14th Dec 2012

Re: Foxground and Berry Bypass - The Roads and Maritime Services (RMS) is seeking approval under Part 3A of the *Environmental Planning and Assessment Act 1979* to upgrade 11.6 kilometres of the Princes Highway between Toolijooa Road north of Foxground and Schofields Lane south of Berry.

As owners of the 'Glenvale' property (CH12250 to CH 13750) which is impacted by the upgrade we wish to lodge our submission to the NSW Department of Planning and Infrastructure so that our concerns can be considered.

Figure 4-15 Typical rural property access (lengths shown are indicative only)

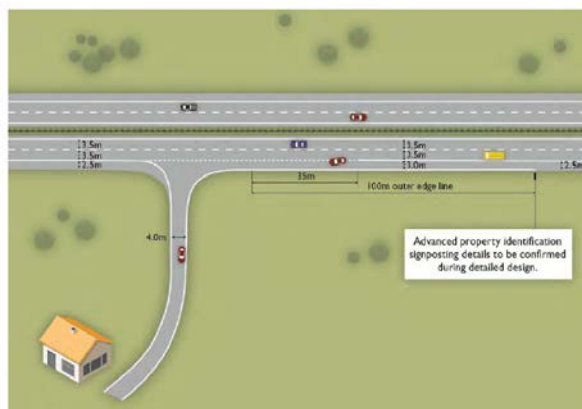
1. Emergency Fire brigade in the event of bush fire
 2. the maintenance crews servicing the Eastern Gas pipeline
- The access to 'Glenvale' (as illustrated in the diagram below from Pg 83 in Chapter 4) shows positive changes such as the increased radius of entry into the property, extra sight distance, level gradient of road surface and extra shoulder width (acting as a deceleration lane). Hopefully these changes will outweigh concerns relating to turning left straight into oncoming traffic flows travelling at 100kph (or more) without a designated acceleration lane. Hopefully driver courtesy will prevail to ensure our safety.

Figure 7.6: Access constraints - Tindalls Lane to Austral Park Road

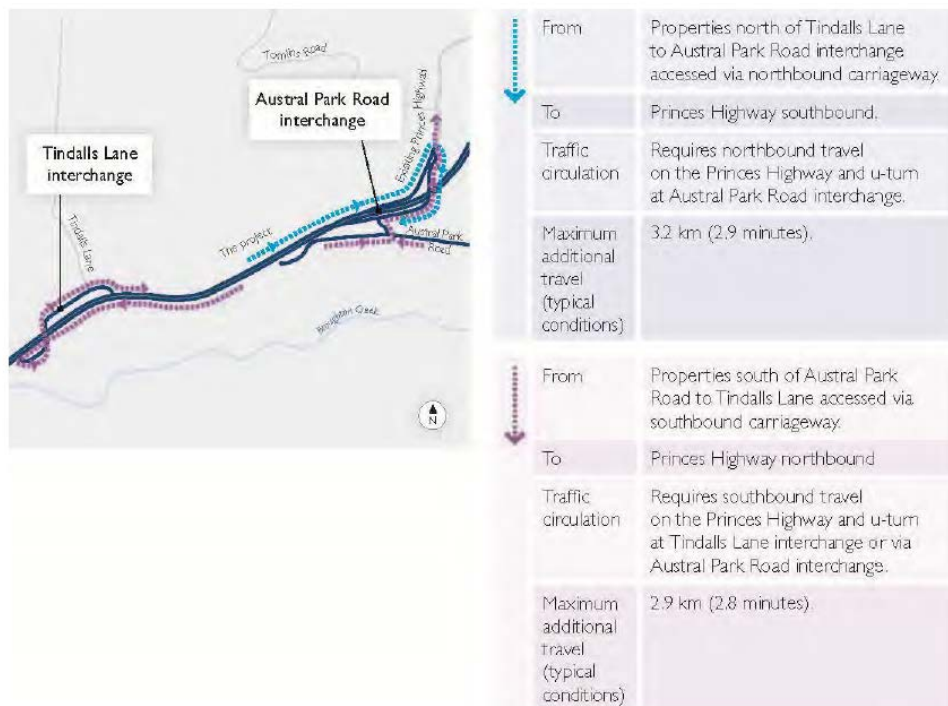
- Although the flyover animation was educational and very helpful in showing us our travel routes as proposed in the EA, our access was unfortunately omitted. This was both worrying and disappointing - especially since it was only discovered by staff when they were trying to reassure us of the improvements at our access!
- The negative aspect of many accesses is the extra mileage & time added to each journey. The RMS state that for each trip will add a maximum travel distance of 3.2km (see Figure 7.6 below from Appendix D - 95). However, over the course of a year the extra mileage $310 \text{ days} \times 3.2\text{kms} = 992\text{kms}$ per year which is the equivalent of a trip to the Gold Coast. The extra mileage would also increase the wear and tear on vehicles and increase the time required by courier drivers delivering parcels etc.

- An added concern is for parents dropping off/picking up children at the bus pick up bay in Tindalls Lane because the extra travel distance and time involved and the added stress this may cause.
